Response to Community Questions Regarding Hunter College-68th Street ADA Project

ENTRANCE ALTERNATIVES STUDY

ADA ELEVATORS AT 68TH STREET STATION

LEXINGTON AVENUE LINE (IRT) BOROUGH OF MANHATTAN

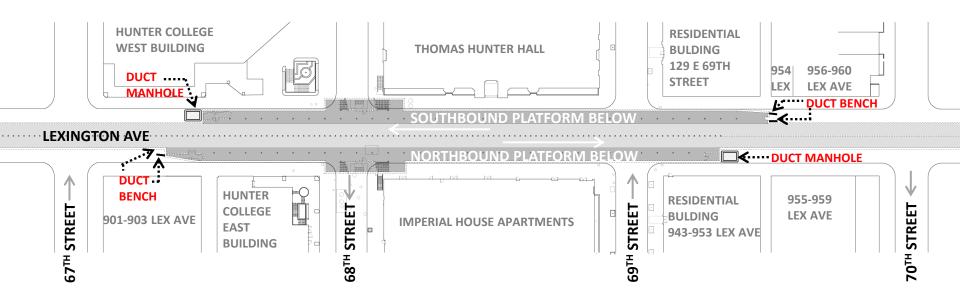
18. Where does the northbound platform end and where do the electrical manholes (that are beyond the platform) end? In front of which addresses?

See page 1 of the attached Entrance Alternatives Study.

NEW 69TH STREET LEVEL PLAN - ALTERNATIVE E3

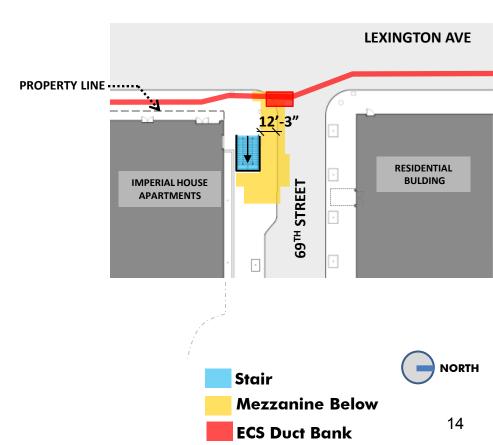
16. Can the entrance on 69th Street East of Lexington be closer to the corner? Closer to building line (as opposed to curb line, as shown on diagram)?

Yes, the stair could be located closer to the building planter as opposed to the curb side and closer to the corner of Lexington Avenue and 69th Street. See page 14 of the attached Entrance Alternatives Study.
